Detailed Site Plan Zaxby's Brooks Drive

DSP-16037-03

STAFF REPORT

SUBJECT: Detailed Site Plan DSP-16037-03
Zaxby's Brooks Drive

Figure 1: Detailed Site Plan

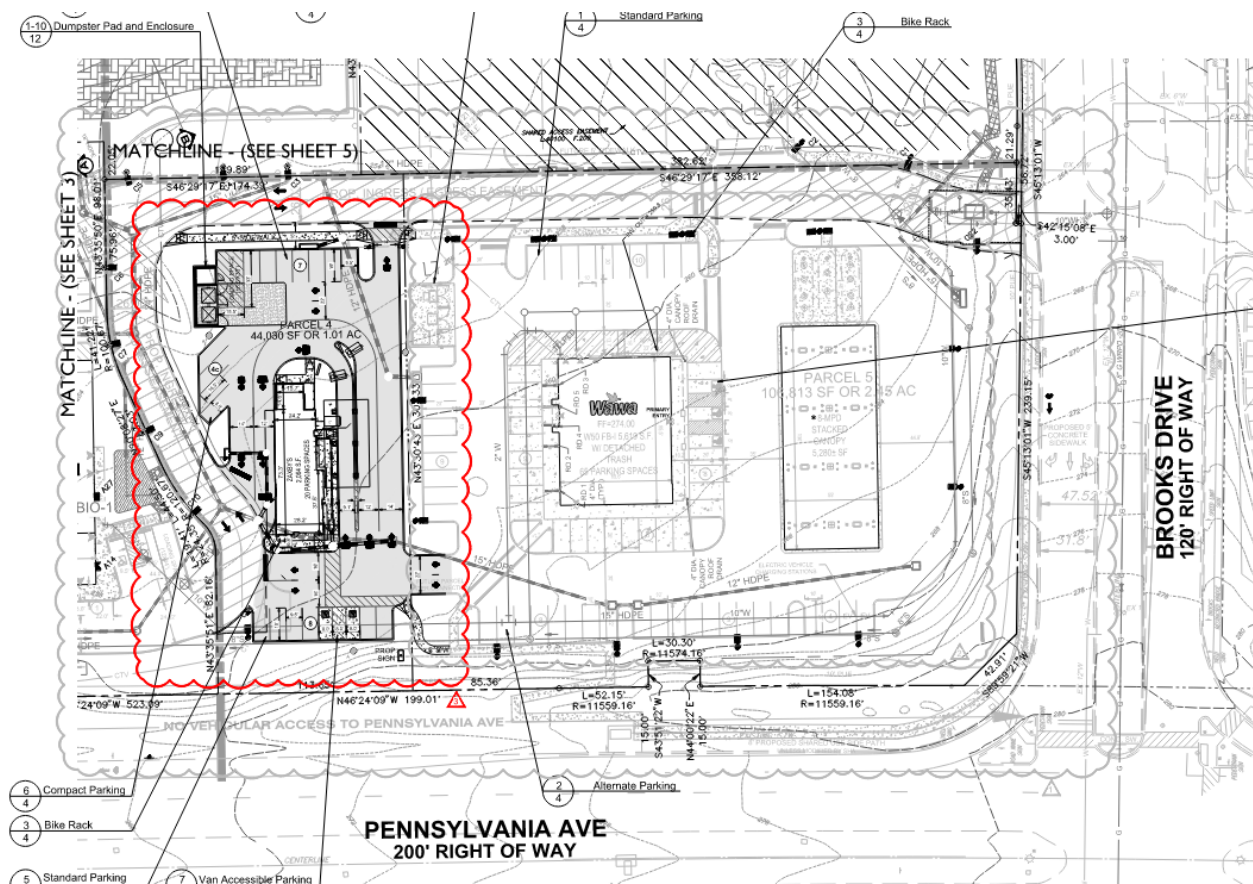
details are included on Sheet 9 of the DSP. However, the distance between the freestanding sign and limits of MD 4 is not labelled, which is conditioned herein to be provided. Pursuant to Section 27-591(b) of the Zoning Ordinance, "only the larger of two (2) sides shall be measured when the two (2) sides of a sign are back-to-back." A condition is included herein requiring the applicant to revise the signage chart to correctly note the provided area of the freestanding sign as 46 square feet.

The parking spaces are located on the southern, northern, and western sides of the building and provide convenient access to customers. A total of 19 parking spaces are provided to meet the minimum 18 space requirement. The parking lot design features a single parking aisle, which is separated from the drive-through lanes, to allow free flow of traffic through the parking lot and minimize the conflicts with drive-through lanes. The vehicular circulation is also separated from the pedestrian circulation to avoid conflicts between the two. Crosswalks are provided where both vehicular and pedestrian circulation systems cross each other. Parking islands with trees are provided within the parking lot. Based on the proposed landscaping and configuration of the parking lot, the proposed parking meets the requirements and allows for adequate and safe circulation through the site.

The submitted site plan includes shared road pavement markings rather than a standard bicycle lane along the property frontage of Brooks Drive, as required by this condition. A condition is included herein requiring the applicant to include a standard bicycle lane along the property frontage of Brooks Drive, prior to certification of the plans, unless modified by DPIE with written correspondence.

1. Prior to certification of the detailed site plan, the applicant and the applicant's heirs, successors, and/or assignees shall:
 - a. Submit a revised and approved stormwater management concept plan and letter that correctly reflects the layout of the proposed eating and drinking establishment, in accordance with Section 27-282(e)(11) of the prior Prince George's County Zoning Ordinance.

- b. Show a standard bicycle lane along the property frontage of Brooks Drive, unless modified by the operating agency in accordance with any Prince George's County Department of Public Works and Transportation adopted standards, or in accordance with a waiver to said standards approved pursuant to the provisions currently codified in Section 23-105(g)(1) of the Prince George's County Code, with written correspondence, per Condition 8.b. of Preliminary Plan of Subdivision 4-20031.

Figure 2: Proposed Building Elevations

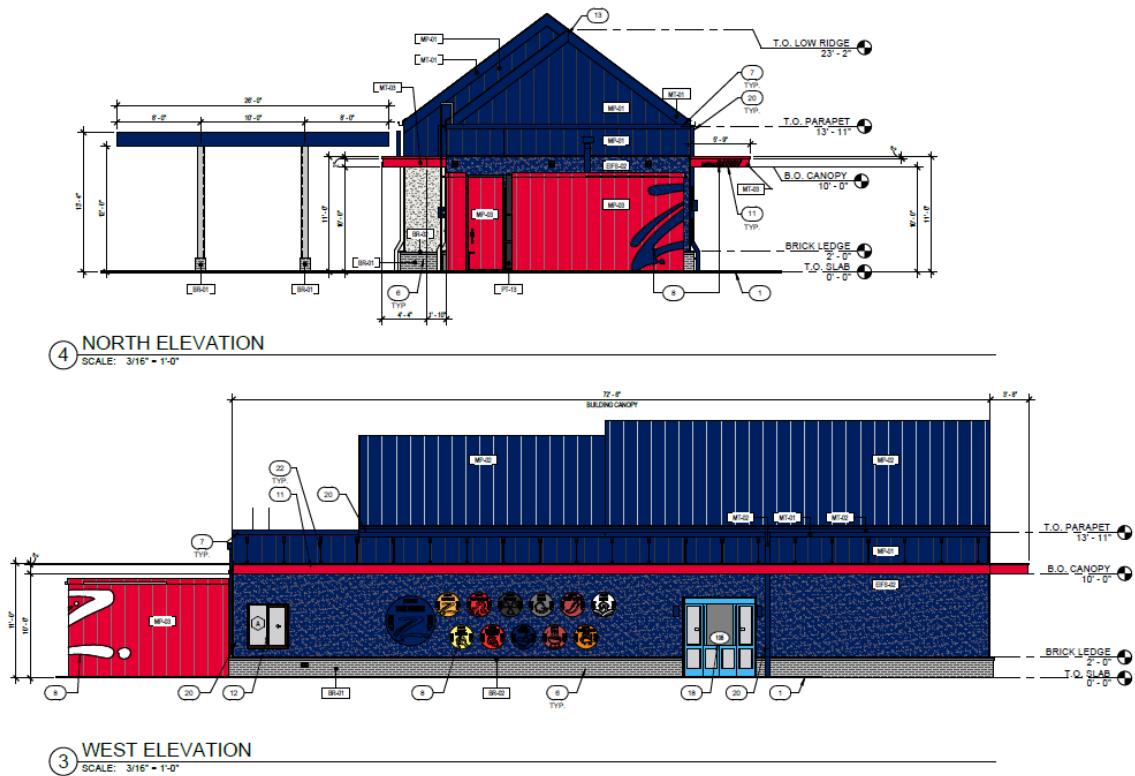
Section 27-274(a)(10) and Section 27-445.15(b)(3) of the prior Zoning Ordinance require an analysis of architecture in terms of building forms, materials, and styles. The layout, scale, and architecture of the proposed building provides an attractive design that reflects a modern aesthetic as well as compatibility with existing buildings on-site. The architecture for the proposed one-story building includes a sloped roof with blue metal panels that

The building entrances are located on the southern and eastern elevations, which are designed with ample glazing and storefront windows to make the building interesting and attractive to customers. A red metal canopy is wrapped around three sides of the building to provide protection from sun and rain, as well as to enhance the aesthetics of the building. There is a single door on the northern elevation of the facility that provides access to the electrical area. The storage area is also located on the north side of the facility, and it is accessible only from within the building. The architectural floor plan does not include a door symbol for the electrical area, despite the north elevation indicating a door at that location. A condition is included herein requiring the applicant to revise the architectural floor plan to add a door symbol for the electrical area, ensuring consistency with the north elevation. The western elevation consists of the drive-through payment and service windows where customers receive orders. This canopy has been designed with materials and colors that are consistent with the proposed building elevations. A separate canopy is proposed over the drive-through lane on the east side of the building. The design, materials, and color scheme of the canopy are compatible with the overall architectural character and elevation of the building.

The six building-mounted signs range in size from 2.5 to 57.56 square feet. Of these, three are vinyl letter signs, two are channel letters, and one is a red circular logo sign. The channel letter and logo signage will be internally illuminated. Sign details and notes are incorporated on Sheet 10 of the DSP, indicating size, color, style, mounting details, and illumination. The submitted architectural elevation shows three extra signs, including one additional "DRIVE-THRU" sign on the drive-through canopy, one Zaxby's rooster and one "ZAX" on the east elevation. A condition is included herein requiring the applicant to ensure all signs shown on all elevations are consistent with the sign details and sign charts. The twelve sauce signs shown on Sheet 10 are part of the ordering menu and, therefore, not classified as signage.

- c. Ensure all signs shown on all elevations are consistent with the sign details and sign charts.
 - d. Pursuant to Section 27-445.15(b)(3) of the prior Prince George's County Zoning Ordinance, revise the area of the Type E sign to 2.083 square feet in the sign detail 3/11.

- j. Revise the architectural floor plan DD-01 to add a door symbol for the electrical area, ensuring consistency with the northern elevation.
